STAFF REPORT
COMMUNITY DEVELOPMENT DEPARTMENT

SUBJECT: H-2021-0087
 Apex West – PP (aka Pinnacle)

Preliminary plat consisting of 208 building lots (207 single-family residential lots and 1 lot for future development of townhomes or multi-family apartments) and 34 common lots on 96.08 acres in the R-2, R-8 and R-15 zoning districts for Apex West Subdivision.

**APEX WEST SUBDIVISION
MERIDIAN, IDAHO
COVER SHEET**

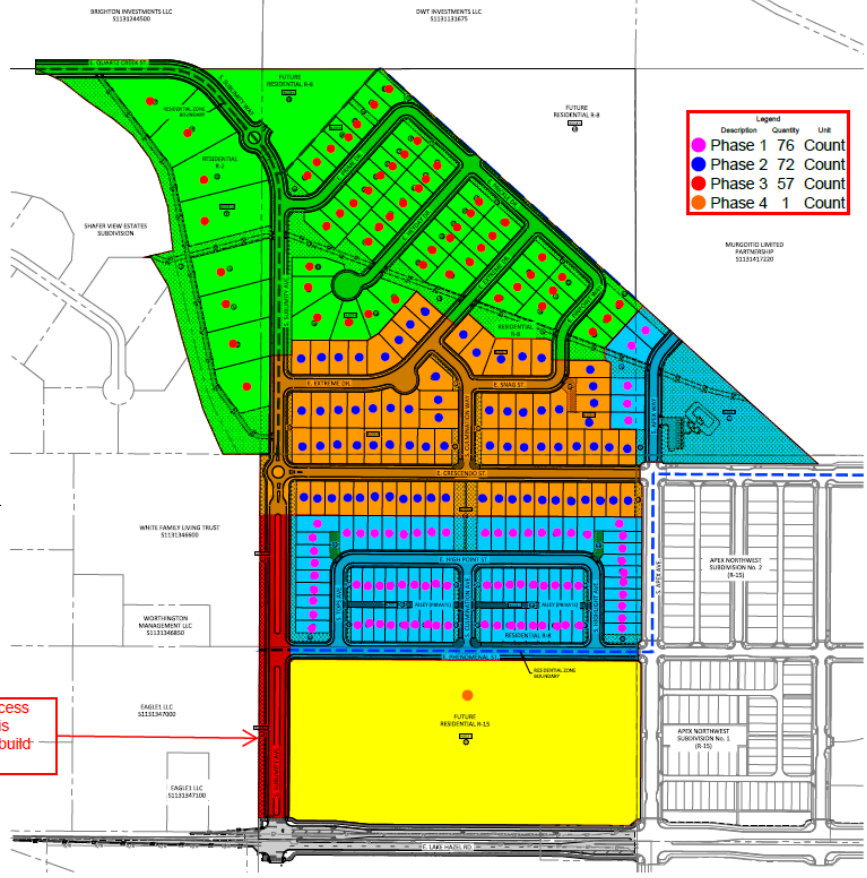
Build temp fire access with phase 1 in this location and final build with phase 4
